# UNITED STATES PATENT AND TRADEMARK OFFICE

APPLICATION NO.	FILING DATE	FIRST NAMED INVENTOR	ATTORNEY DOCKET NO.	CONFIRMATION NO.
10/735,697	12/16/2003	Sung-Jae Cho	P56999	3543

## Office Action Summary

**DETAILED ACTION**

#### **Masataka Reference**

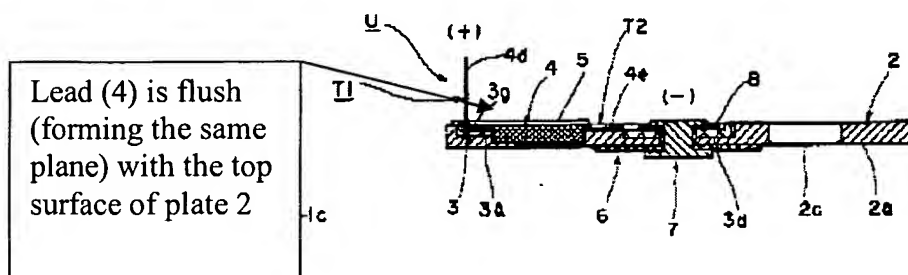
Figures 1 and 2 of the Masataka reference clearly shows the cavity (2a) and the lead plate (4a) in the cavity, thus the lead plate will have to be pressed into the cavity otherwise the lead plate would be out side of the cavity.
